NOTE

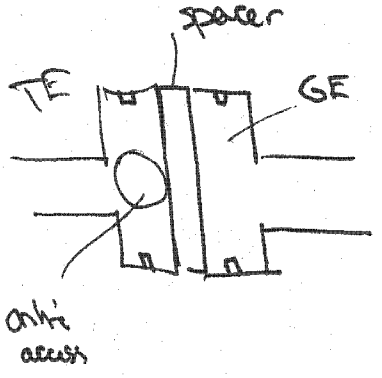
Coupling
only access to TE

Coupling balance
- why

why - where initially

Need capital modifications
move B/N probes from over cover to bearing cap strong backs

Need studs U1 and U2
backplates

B/N - shaft relative to bearing housing
